BID ADDENDUM NO.1

2181539 Bank on Buffalo, Niagara Falls, NY

There was an error during the printing process that caused the structural & HVAC items to not appear in the Architectural drawings. Some of the drawings being replaced are only to show the missing items for clarification. No actual changes are occurring on these sheets. Any changes to the drawings are clouded & tagged.

1 ENLARGED ENTRY PLAN
A401 SCALE: 1/2" = 1'-0"

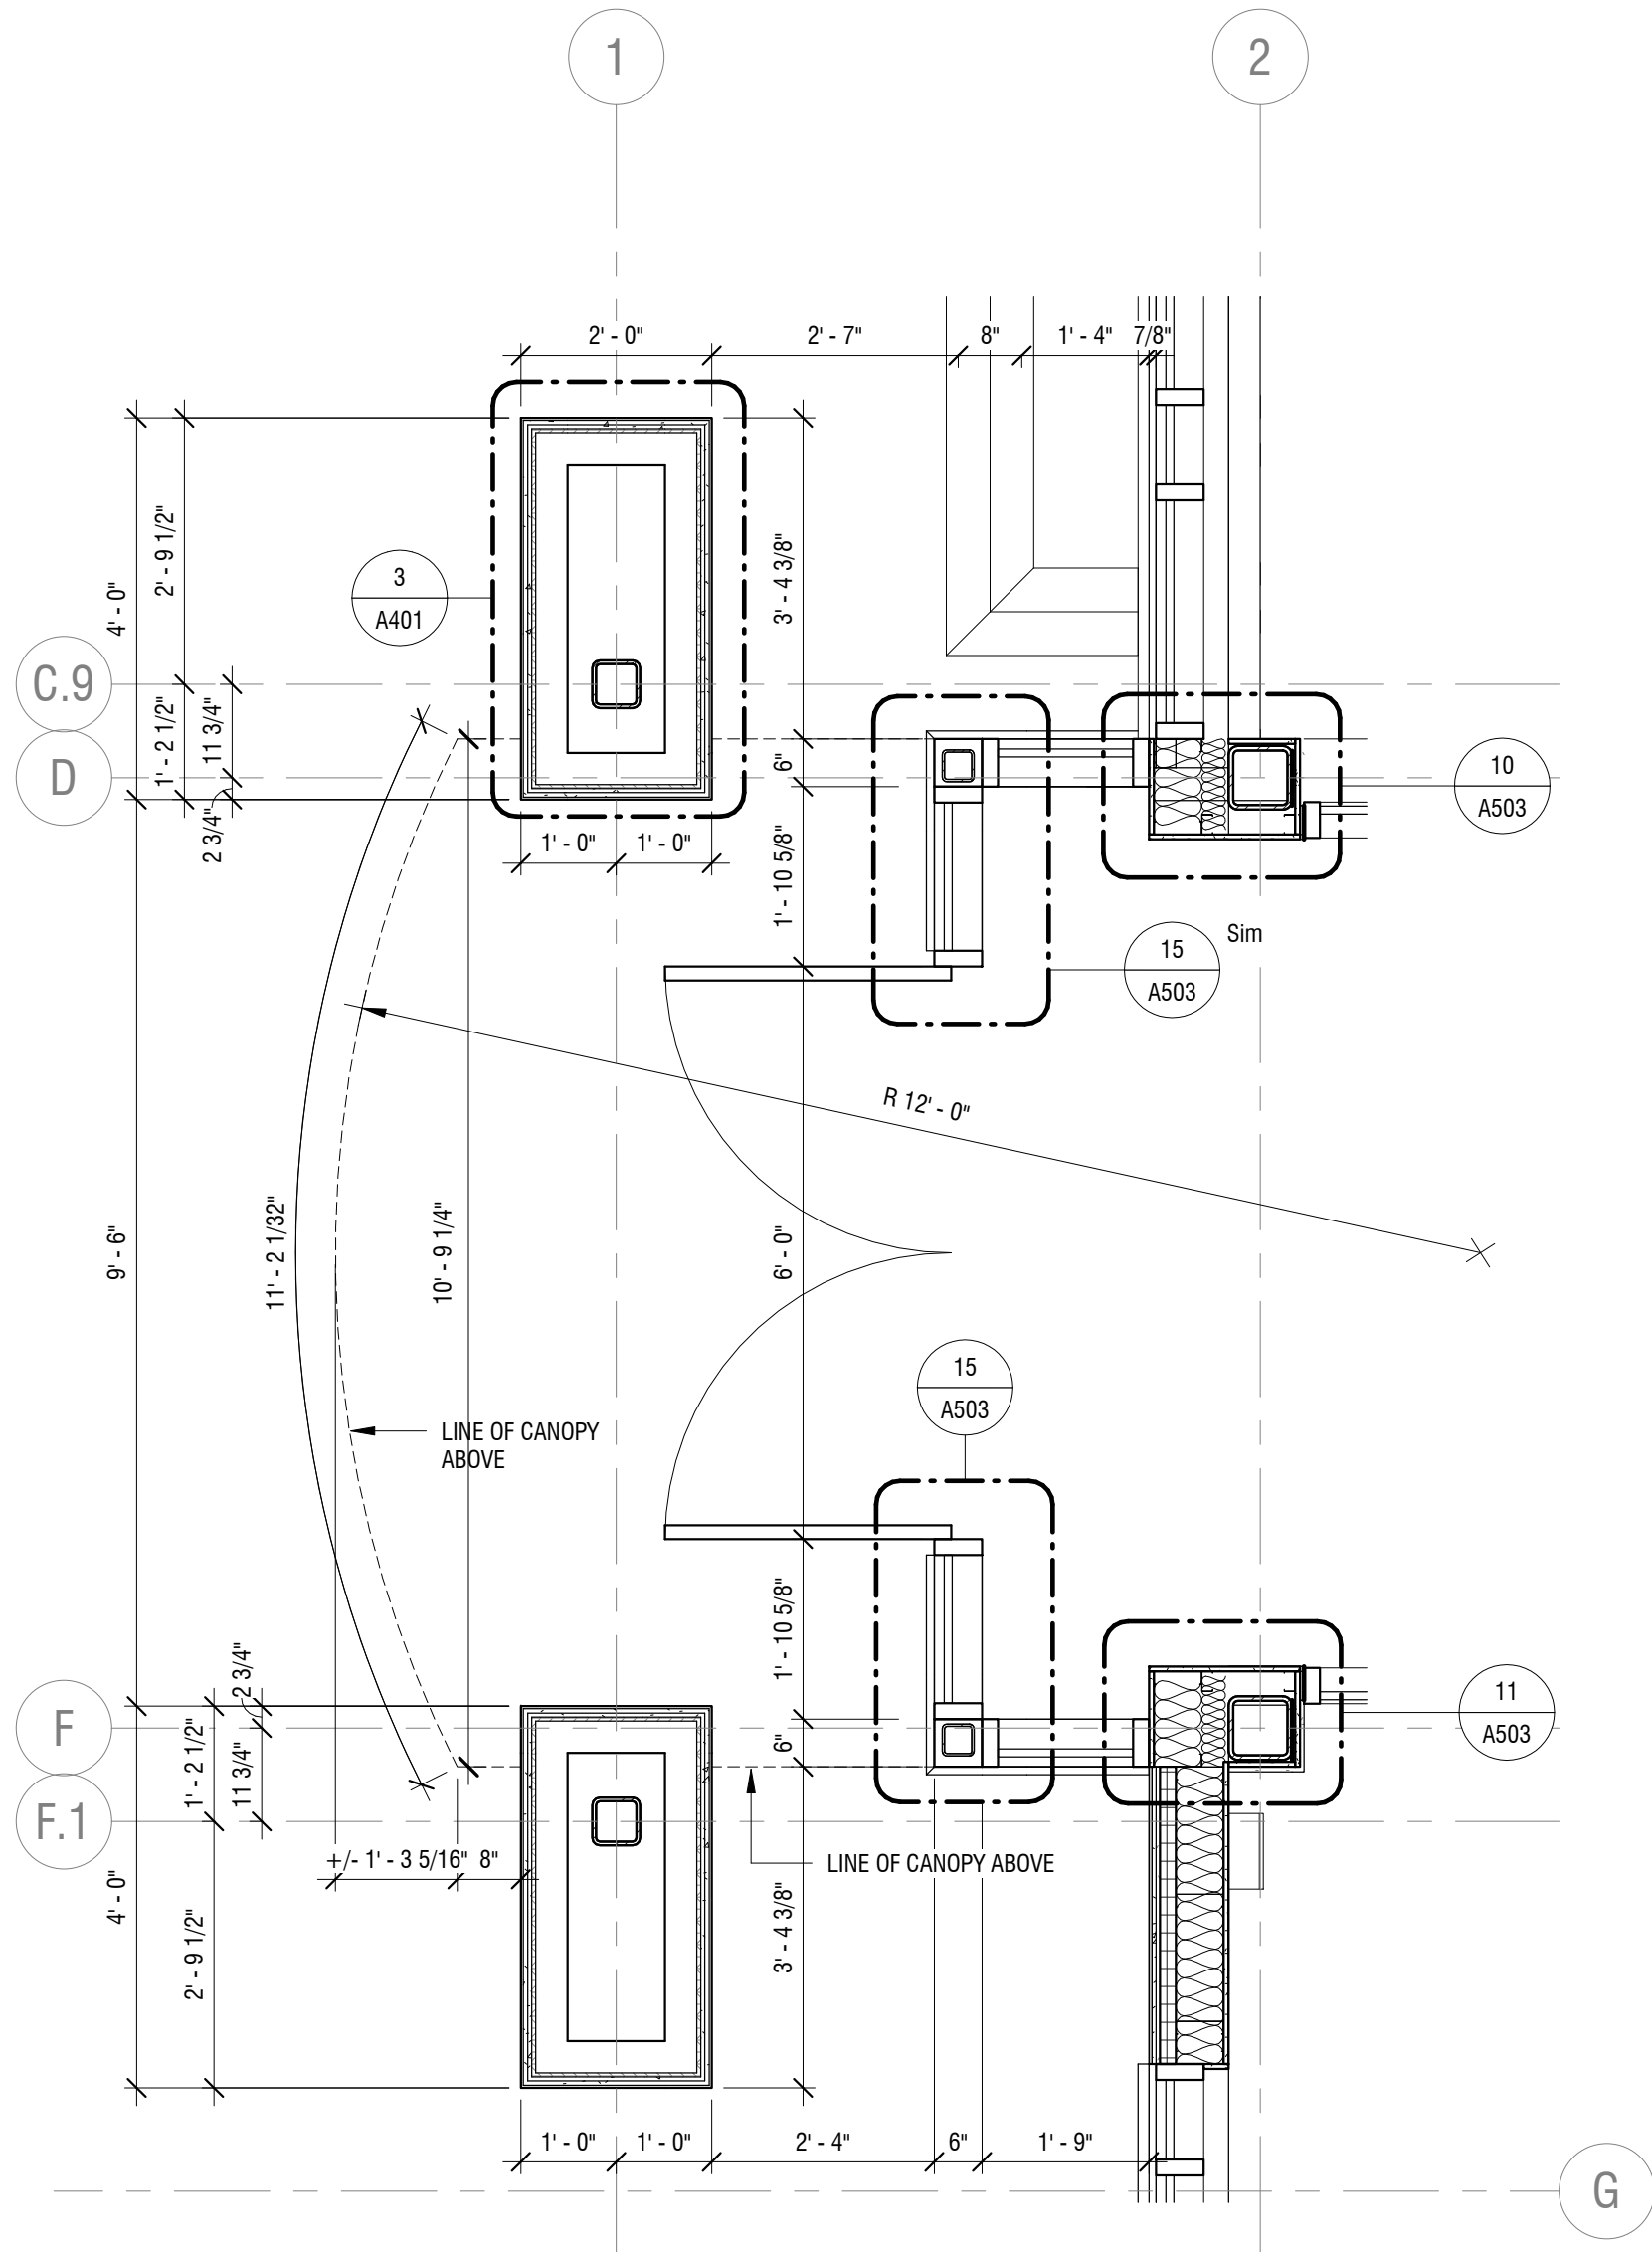
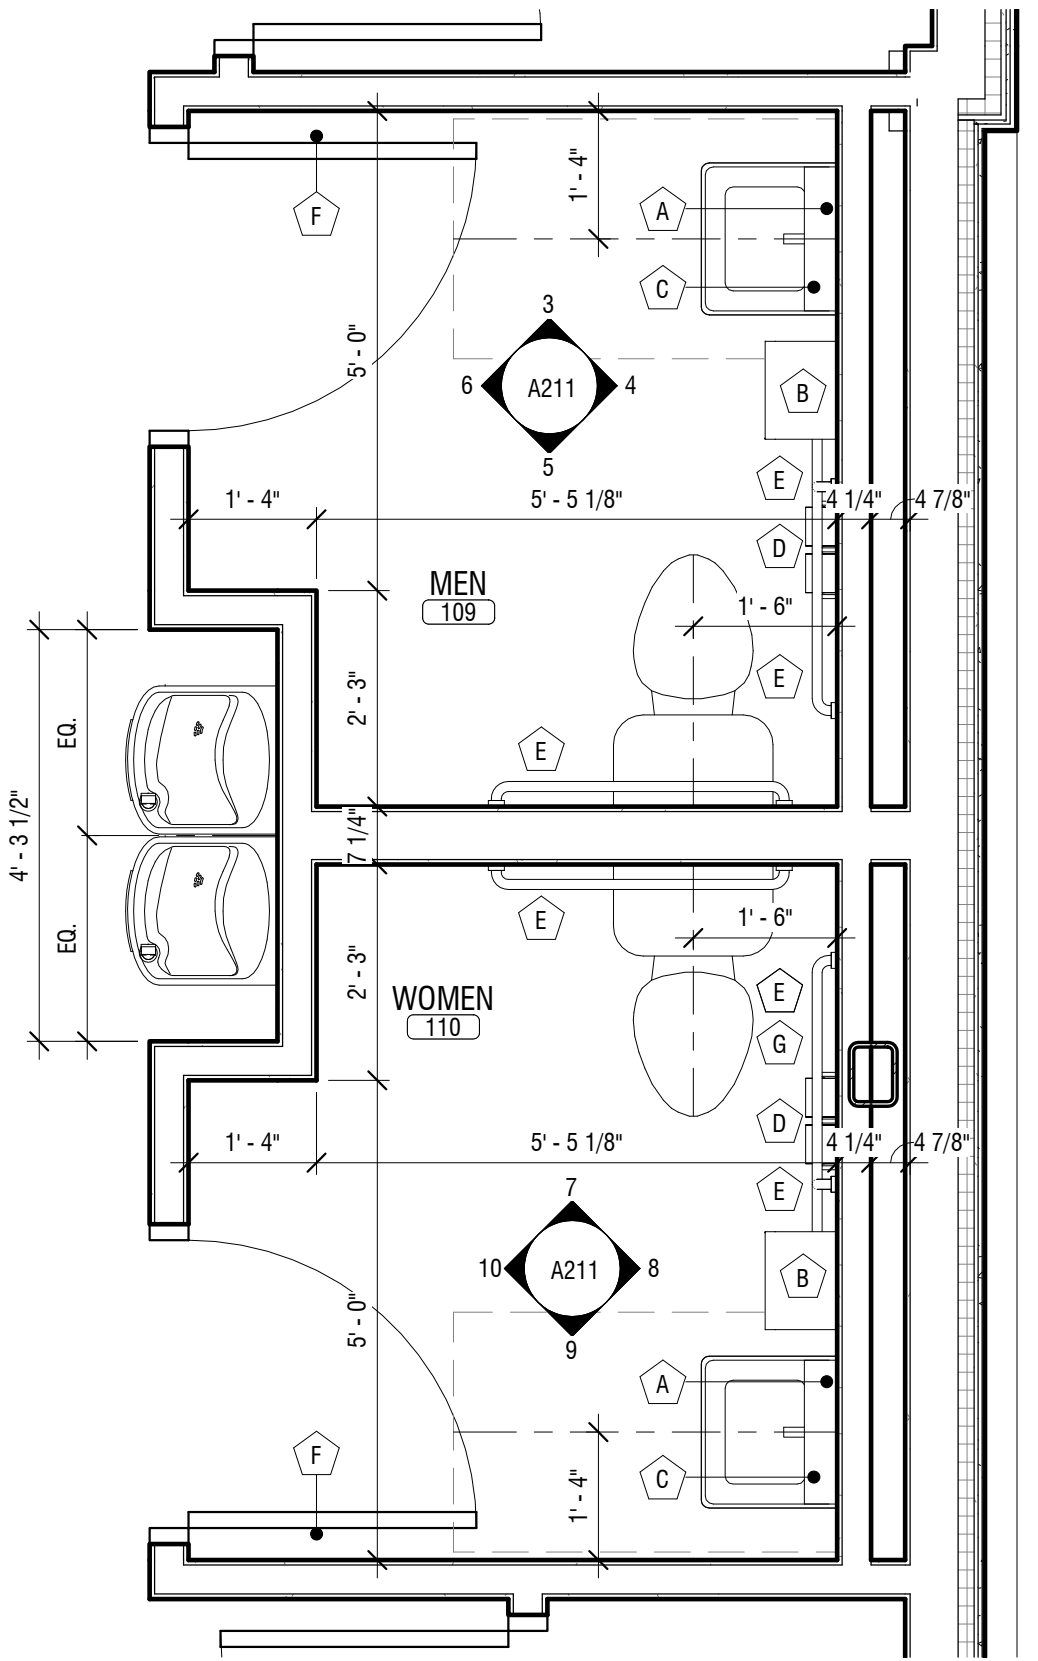
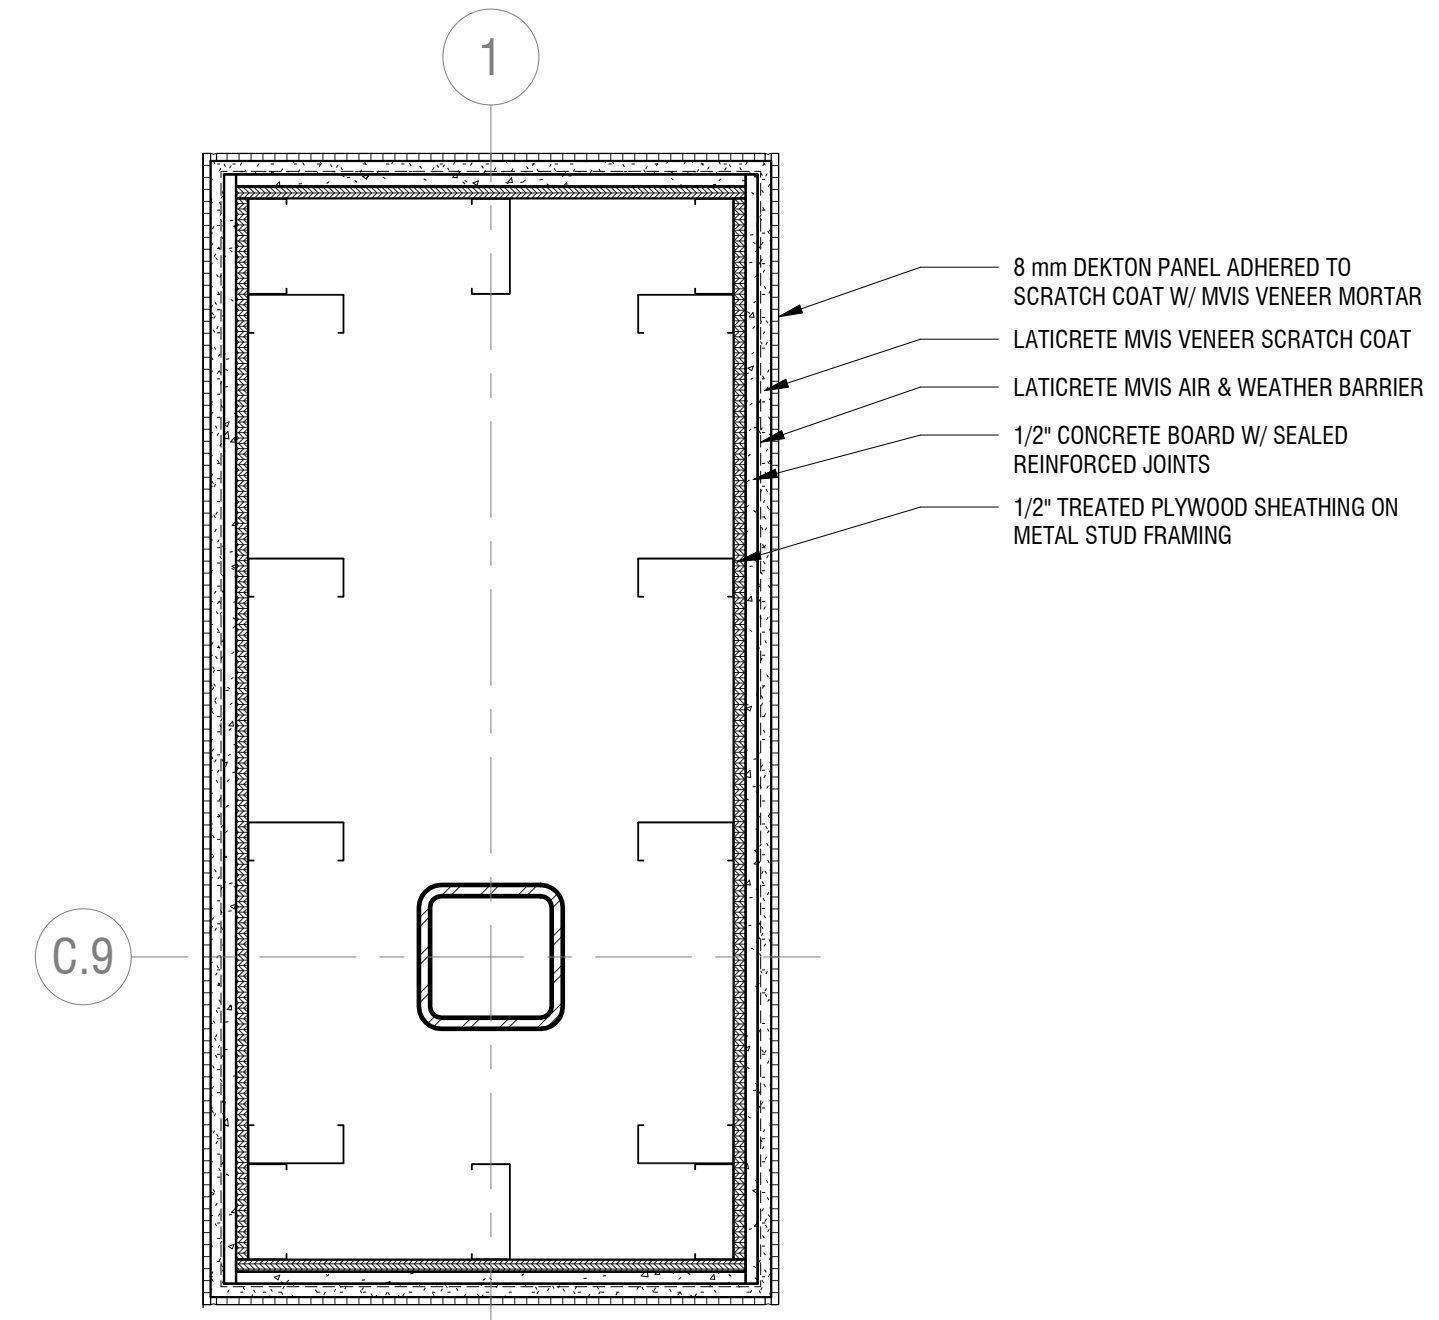
- L. Drawing A401**
 - 1. DELETE Drawing in its entirety
 - 2. ADD replacement Drawing A401
 - 3. HVAC & structural shown on drawings.
